# NOTICE OF THE REGULAR MEETING OF THE PLAN COMMISSION

### AGENDA FOR REGULAR MEETING VILLAGE OF TINLEY PARK PLAN COMMISSION

### PLAN COMMISSION STAFF REPORT

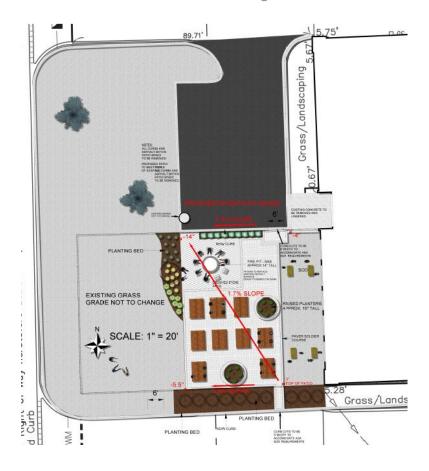
The patio is expected to have a four or five-foothigh fence installed around the perimeter and would only be entered by entering the building. The fence would be a black aluminum fence in the wrought iron style. Fencing is not allowed in a primary front yard on any lot, with the exception of an allowance for patios in the Legacy District. While patios are not typical in industrial areas, it will add an attractive and activated entrance to the business. The fence has a goal of delineating the space where alcohol can be consumed onpremise and helps to protect customers. The proposed fencing will be a 75% open design fence that does not present any visibility or safety issues from the street or driveways.

# Open Item #1: Discuss the requested Exception to the fence regulations to permit a fence to be located in a primary front yard.

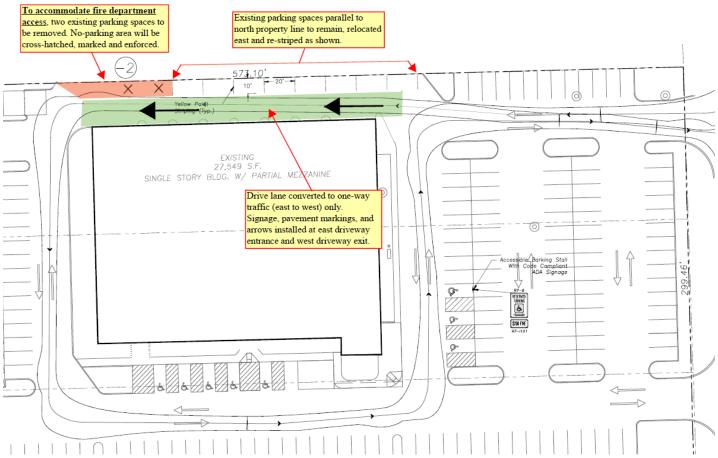
There are parallel parking stalls located on the north side of the property. These stalls were illegally striped without approval and have reduced the aisle width to around 17-18 feet and make truck circulation around the site difficult when vehicles are parked there. To alleviate the truck circulation concern, the petitioner is eliminating two parking stalls nearest to the dumpster to accommodate truck turning. The area will be hashed and marked "No Parking Permitted". Due to this parking being an immediate issue related to emergency response, the Petitioner has agreed to make these changes this year and is working to get it completed as soon as possible.

The existing aisle width does not meet the aisle width minimum of 24 feet and cannot safely be used as a two-way access. Staff is recommending that this aisle be revised to be a one-way drive aisle with appropriate striping (arrows) and signage ("One-Way  $\rightarrow$ " and "Do Not Enter"). If changes are not made, a Variation would be required.

# Open Item #1: Discuss the northern drive aisle on the existing site and staff's recommendation for conversion to a one-way aisle.

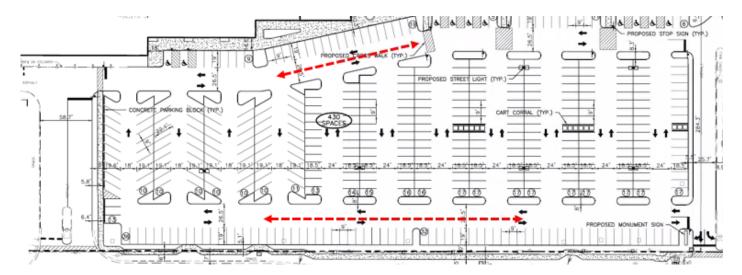
### 6. Substantially diminish or impair property values within the neighborhood.

Since were not changing any existing use, only extending it, the neighborhood should be un-affected for use during the off hours in the evenings and weekends.

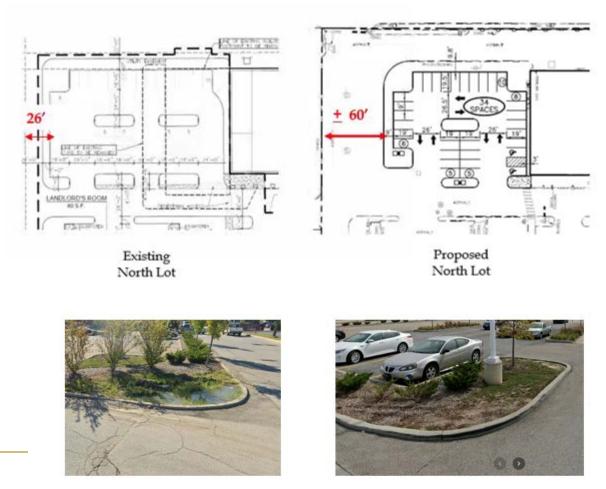
Hailstorm Brewing Co. 8060 186th St. Tinley Park, IL 60487 ● 312-961-0568

Daniel Ritter Village of Tinley Park 16250 Oak Park Ave, Tinley Park, IL 60477

Re: Parking Variance

Louis Perna Region Construction 8056 W. 186<sup>th</sup> St. Tinley Park, IL 60487

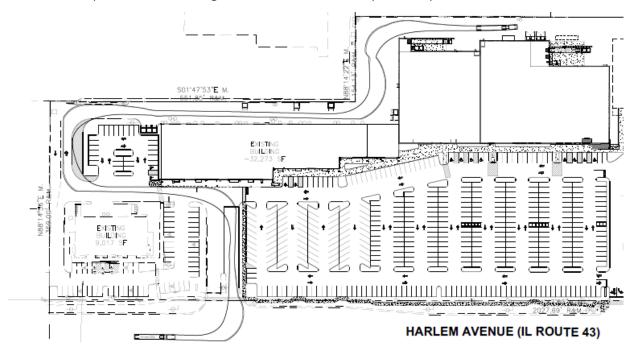
Christopher Schiller

Hailstorm Brewing Co. 8060 186th St. Tinley Park, IL 60487 ● 312-961-0568

Re: Parking Allowance
